# INDIAN ORCHARD BRANCH LIBRARY

44 Oak Street  
Springfield, MA 01151

## FACILITIES REPORT 12/2/96

FIG. 1

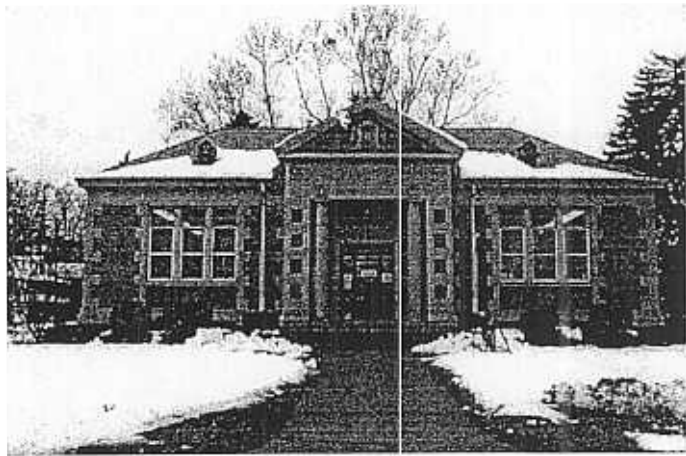
**RAMPS:** ADA 4.8 A ramp at the front of the building is required for access. An existing set of steps on the exterior consists of 5 risers with a second set of steps inside the vestibule consisting of two steps. A 48'-0" long ramp would be required with handrails and guardrails to reach the finish floor elevation. The exterior book drop is located at the top of the exterior steps. See figure 1.

Fig 2

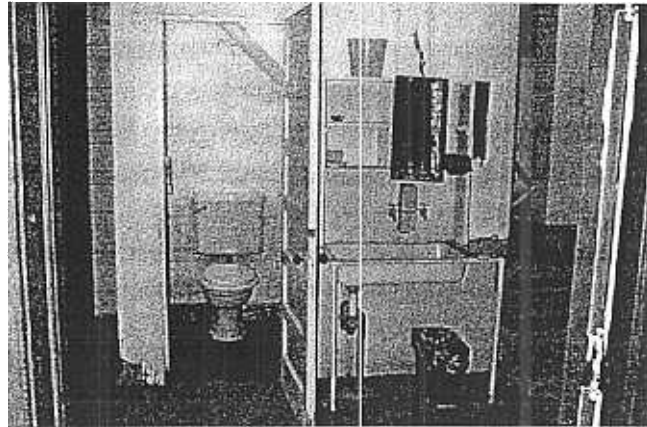
**STAIRS:** ADA 4.9 The second means of egress on the back of the building requires new handrails and a top landing at the exit door. Handrail are needed on the front steps on the exterior and in the entry vestibule. See figure 2.  
ADA 4.3.1 A 36" wide minimum sidewalk is required from the second means of egress door to safe location away from the building.  
ADA 13.5 The egress door to the exterior is only 28" wide and is required to be 36" wide.

A second inaccessible toilet room is located directly off of the private office. This 4'-0" x 5'-0" room consists of a toilet and sink. See figure 2.

FIG. 3

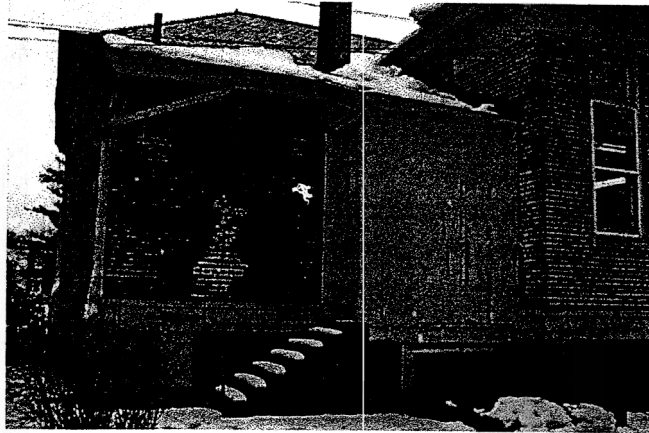
**STAIRS:** All interior and exterior stairs to the building do not comply with the handrail requirements. All staircases and steps are required to have handrails and guardrails on both sides of the stairs that extend 12" beyond the top riser and 12" + one tread at the bottom riser. All handrails should be 1-1/4" to 1-1/2" in diameter and have 1-1/2" clear space between the wall. The staircase leading to the basement only provides 5' 6" of head clearance and not the 6' 8" minimum clearance required by code. See fig. 3.

**MASONRY:** The exterior masonry requires repointing in areas around the entire building. Large amount of repairs are needed near the rear means of egress of the building. See figure 3.
